Access Compliance Report

Public Rights-of-Way

(Curb Ramps)

Intersection ID: 31633	Main Street: KARAM_LN	Cross Street: MARY_JO_HELMS_DR	Location: SE
ADA ID: 20FD3B52F3C2	Ramp Type: PerpDiag	Initial Pass/Fail: Fail	Overall Compliance: No
Severity Score: 25			
Codes/Mitigation Info/Possible Solution		Field Measurements/Component Compliance

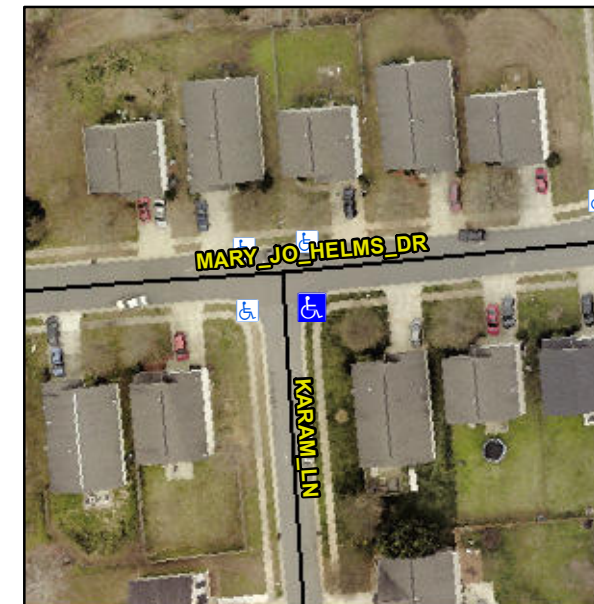
Not Found, R304.2.2, R304.5.3

Compliance	Description	Data	Compliance	Description	Data
N/A	Ramp Length (in)	55.0	No	Ramp Slope (%)	8.9
Yes	Ramp Width (in)	48.0	No	Ramp XSlope (%)	6.1
N/A	Flare Type LT	N/A	N/A	Flare Type RT	N/A
N/A	Flare Slope LT (%)	N/A	N/A	Flare Slope RT (%)	N/A
N/A	Flare Traversable LT?	N/A	N/A	Flare Traversable RT?	N/A
N/A	Landing Length (in)	N/A	N/A	DWS Provided?	N/A
N/A	Landing Width (in)	N/A	N/A	DWS Contrast?	N/A
N/A	Landing Slope (%)	N/A	N/A	DWS Length (in)	N/A
N/A	Landing X Slope (%)	N/A	N/A	DWS Full Width?	N/A
N/A	Landing Curb? (Y/N)	N/A	N/A	DWS Offset (in)	N/A
N/A	Shared Landing?	N/A			
N/A	Gutter Ponding?	N/A	N/A	Gutter Slope (%)	N/A
N/A	Gutter Lip Ht (in)	N/A	N/A	Gutter X Slope (%)	N/A
N/A	Painted X Walk1?	No	N/A	Painted X Walk2?	No
	X Walk 1 Direction	To N		X Walk 2 Direction	To W
N/A	X Walk 1 Width (in)	N/A	N/A	X Walk 2 Width (in)	N/A
	X Walk 1 Slope (%)	3.0		X Walk 2 Slope (%)	4.7
	X Walk 1 X Slope (%)	4.1		X Walk 2 X Slope (%)	2.3

N/A	Ramp inside XWalk1?	N/A	N/A	Ramp inside XWalk2?	N/A
	Road Slope (%)	5.4	N/A	Clear Space?	N/A
	Road X Slope (%)	3.6	N/A	Clear Space to XWalk (in)	N/A
N/A	Any Obstructions?	N/A	N/A	Storm Grate/Utility Hazard?	N/A
	Obstruction Type			Storm Grate/Utility Type	
		N/A			N/A
		Yes		Surface Condition? (G/P)	Good

Remove & Replace Curb Ramp With Two New Directional Ramps or Equivalent.
